COMBINED PRELIMINARY AND FINAL
DRAINAGE REPORT
for
OHANA SUBDIVISION
EL PASO COUNTY, COLORADO

March 14, 2024

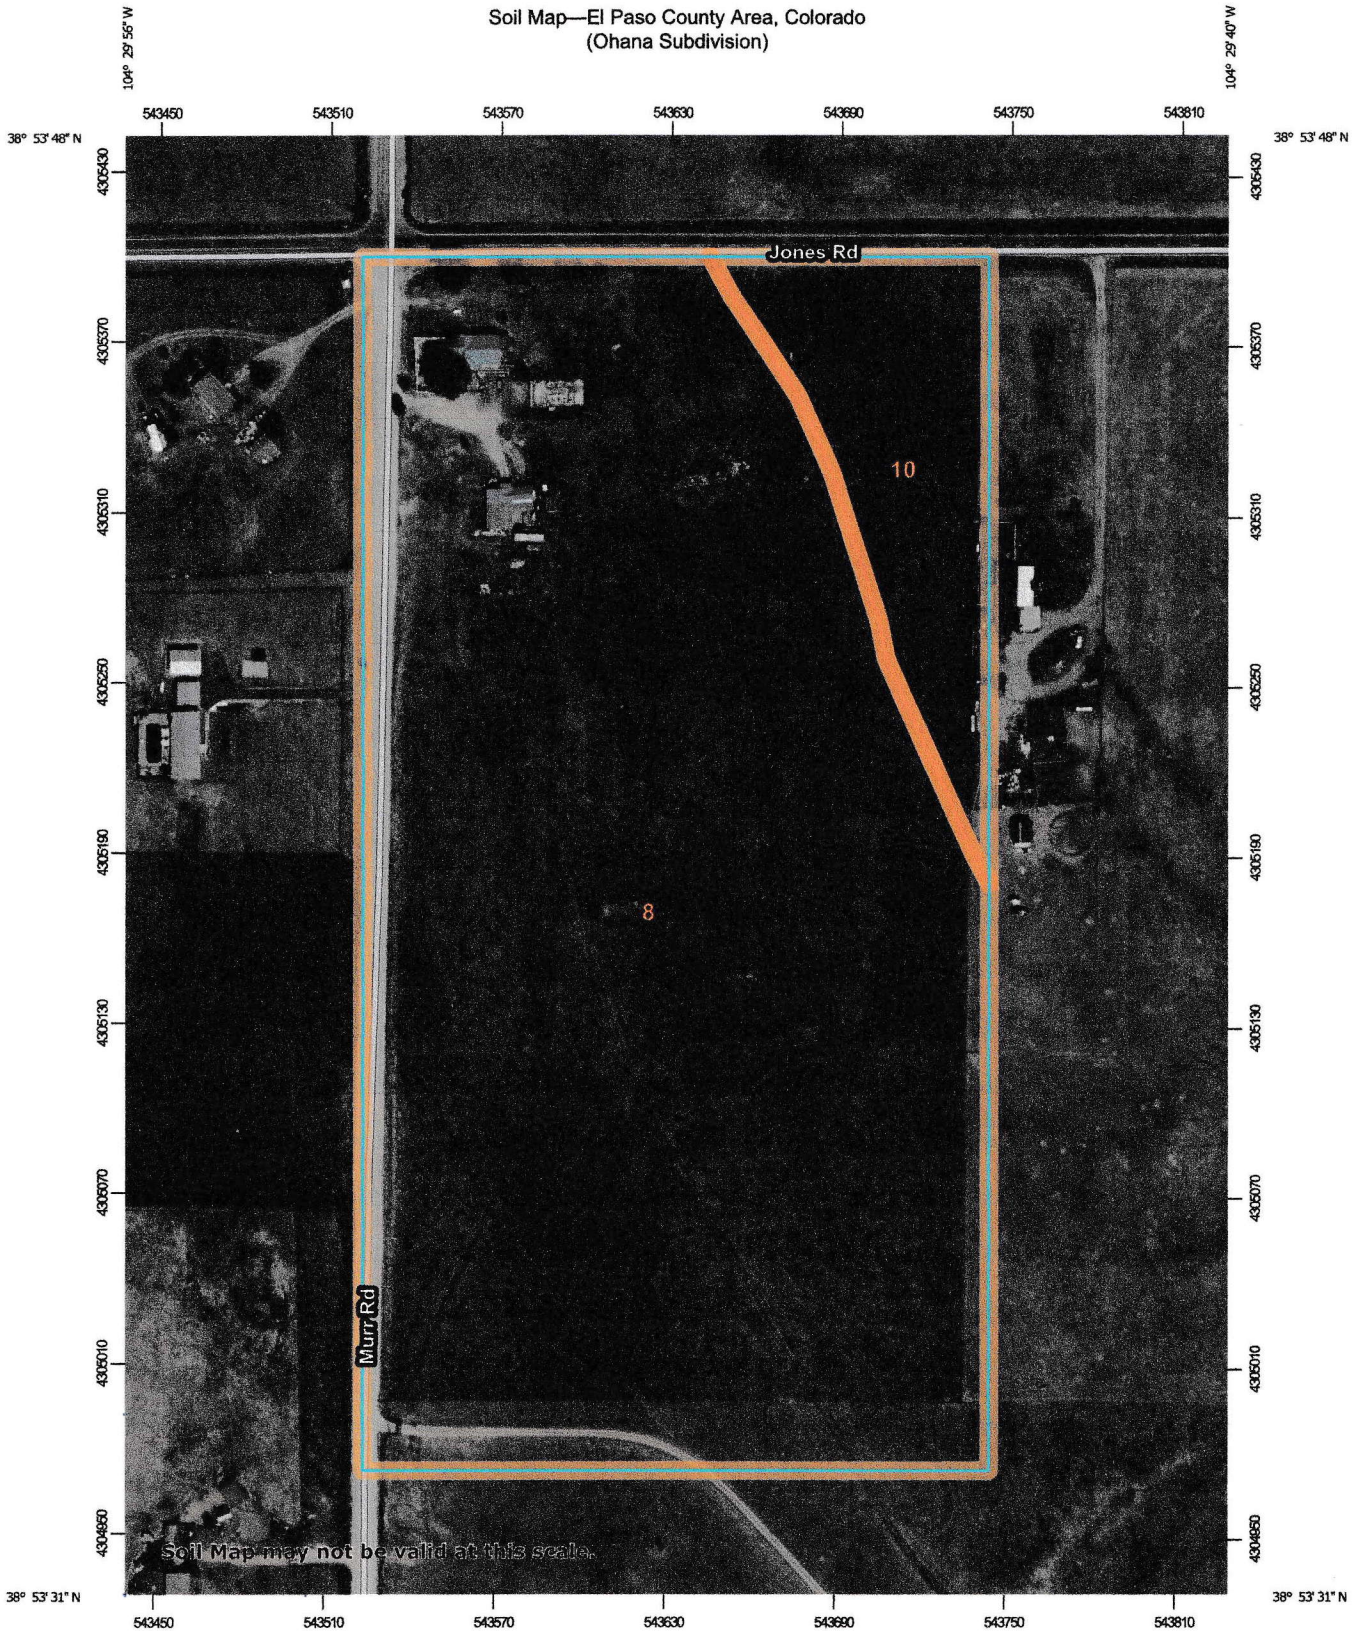
Do not combine
Drainage &
Bridge Fees.
